PRODUCT CHANGE NOTICE

PCN24-066**NOTIFICATION DATE: September 30, 2024****MODELS AFFECTED**

ADCA5191
ADCA5191-EVALZ
ADCA5191ACPZ
ADCA5191ACPZ-R7

FROM:**TO:****EFFECT OF CHANGE:**

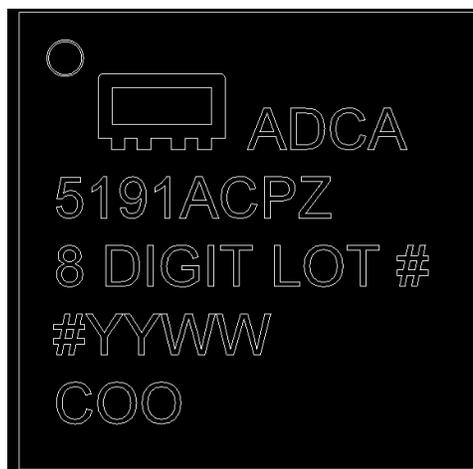
Change of product marking due to change of test location from Analog Devices to Mini-Circuits.

This is a marking change that alters only the appearance of the part. No changes to the design. Products manufactured by Mini-Circuits will have the updated marking.
